RESPONSE TO REQUEST FOR ADDITIONAL INFORMATION

APR1400 Design Certification

Docket No. 52-046

RAI No.: 239-8076
SRP Section: 16 – Technical Specifications
Application Section: 16.3.3
Date of RAI Issue: 10/09/2015

← breaker in RTCB

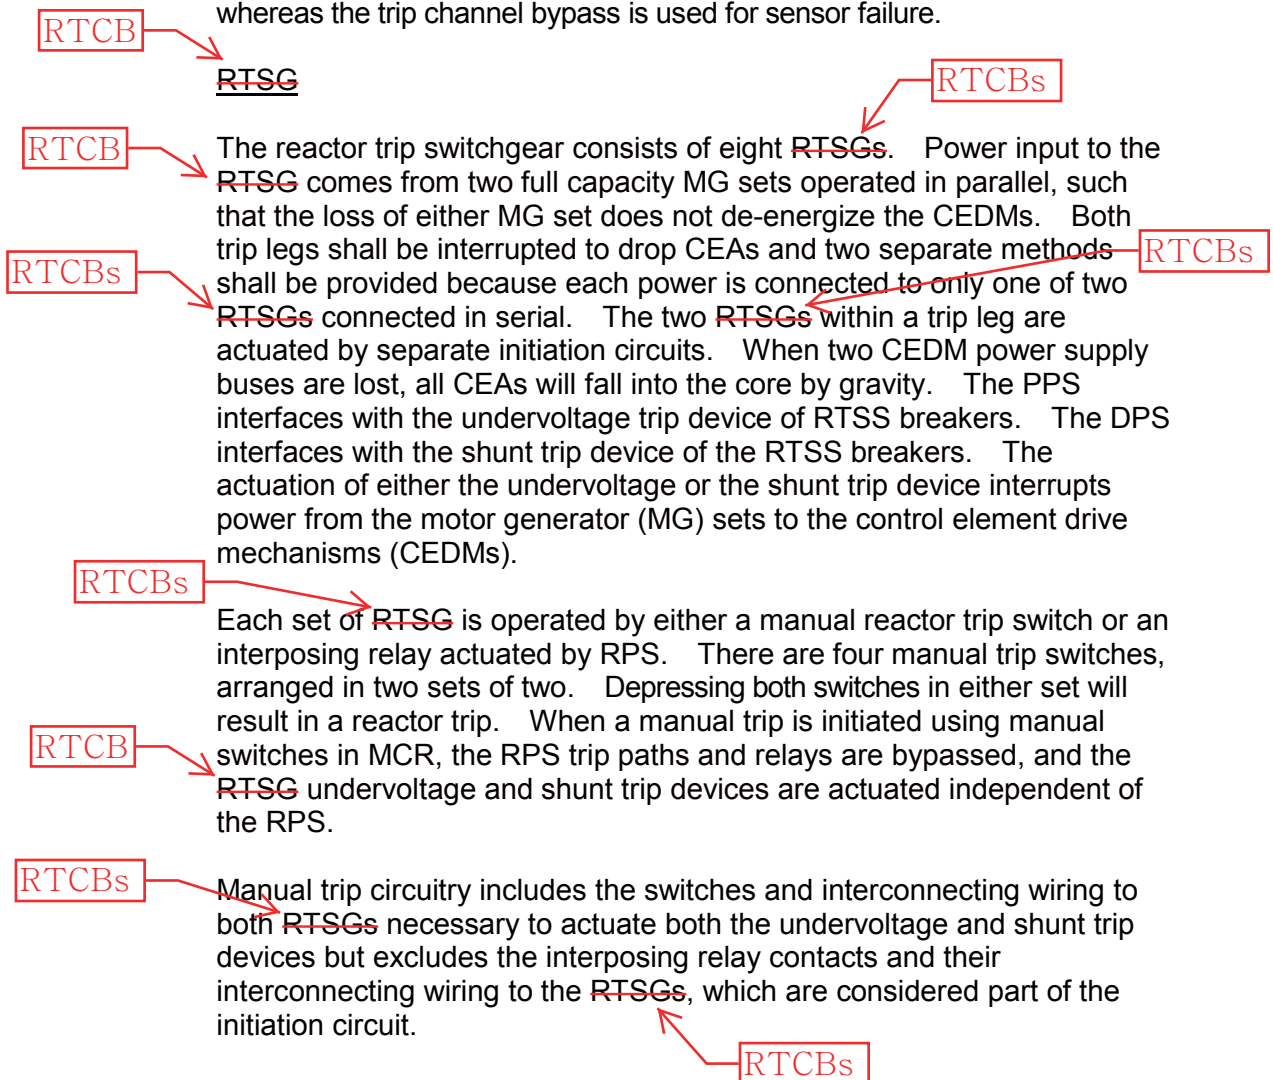
The RPS initiation logic consists of an "OR" circuit for each undervoltage and de-energizes interposing relays. Each interposing relay opens one ~~switchgear in RTSG~~ in turn.
